PLANNING

Project
**38 Chester Terrace
NW1 4ND**

Drawing Title
Proposed Section CC

Drawing No.	Rev.
P2202	E

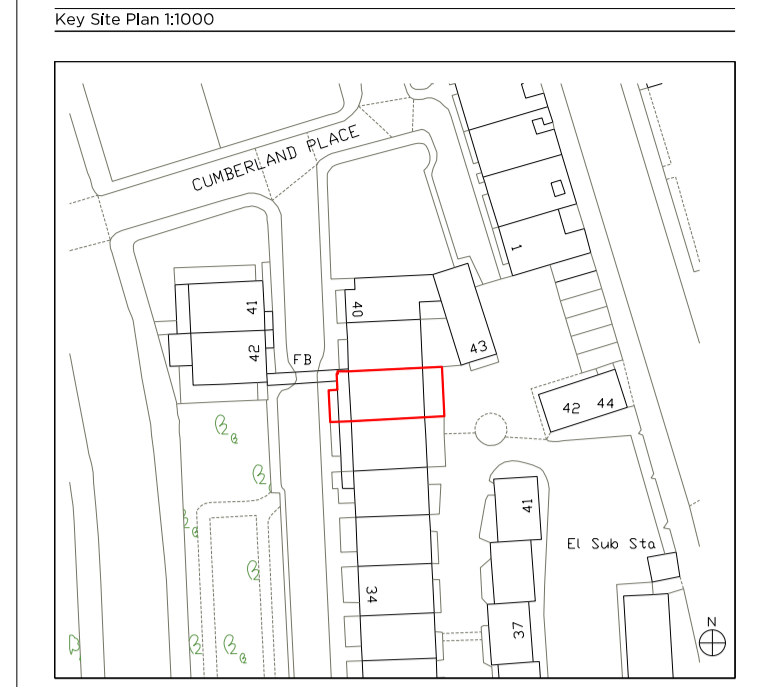
Revision Notes	
Rev. B	29.03.2021
B.1	Works to remove existing lower ground floor slab and lower floor level omitted. Proposed floor level to remain as existing.
B.2	Powder Room (r103) repositioned away from rear elevation.
B.3	Proposed door DUG.01 revised to be a traditionally detailed timber 4 panel door.
Rev. C	06.04.2021
C.1	Rear Courtyard layout amended. New staircase to Upper Ground Floor Level added. Proposed built-in furniture and planters.
C.2	Coffer ceilings in Gym and Kitchen omitted.
C.3	Comics added to Kitchen, Bar and Master Ensuite.
C.4	Coffer ceilings added to Bar and Study.
Rev. D	08.04.2021
D.1	Proposed excavation down to depth of original floor.
Rev. E	03.03.2022
E.1	Roof terrace reverted to existing roof layout, new rooflights to replace existing.
E.2	Rear courtyard amended, Condenser units in proposed joinery, stair relocated.
